NEDO-32983-A, Revision 2

General Electric Methodology for Reactor Pressure Vessel Fast Neutron Flux Evaluations

SUBJECT: FINAL SAFETY EVALUATION REGARDING REMOVAL OF METHODOLOGY LIMITATIONS FOR NEDC-32983P-A, "GENERAL ELECTRIC METHODOLOGY FOR REACTOR PRESSURE VESSEL FAST NEUTRON FLUX EVALUATION" (TAC NO. MC3788)

Figure 5-1. Schematic of a Quadrant of the Reactor Core

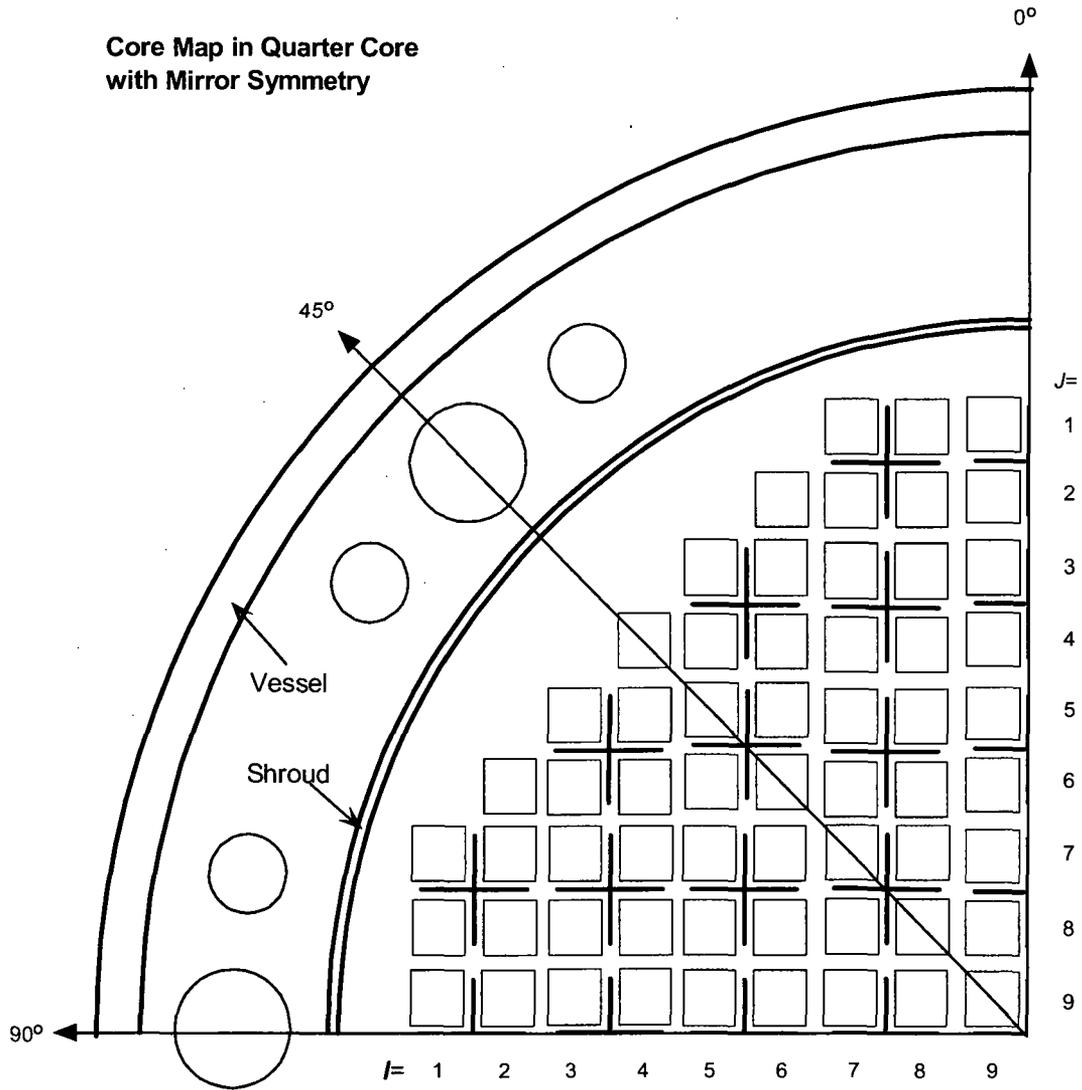
Provide an explanation for the radially-dependent bias in the benchmark experiment C/M data of Figures 5-4, 5-5 and R9-1. Does this indicate that calculations based on the proposed methodology will over-predict the fluence at locations inside the vessel inner-wall? Provide justification for not including this bias in the calculation methodology. In view of the data in Figure 9-1:
